# Access Compliance Report

## Public Rights-of-Way

Intersection ID: 53894	Main Street: INVERNESS_BAY_RD	Cross Street: PERTH_MOOR_RD	Location: SE
ADA ID: 703B2B1DCF67	Ramp Type: Perp	Initial Pass/Fail: Fail	Overall Compliance: No
Severity Score: 12.5			
Codes/Mitigation Info/Possible Solution		Field Measurements/Component Compliance

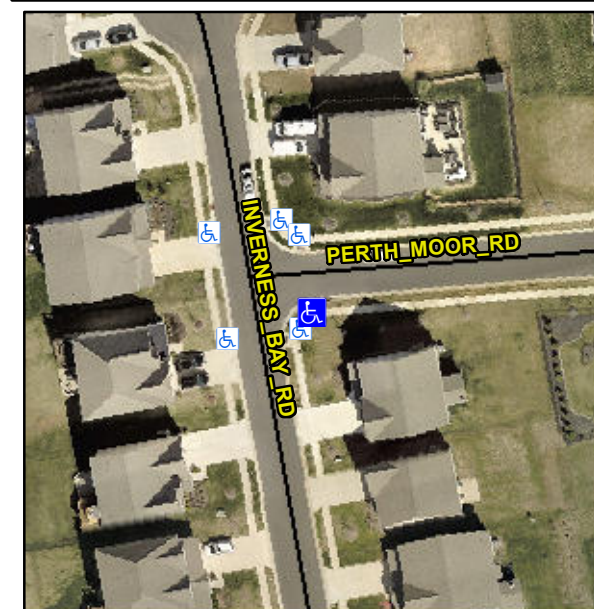
**Not Found, R304.2.2**

**Remove & Replace Entire Ramp.**
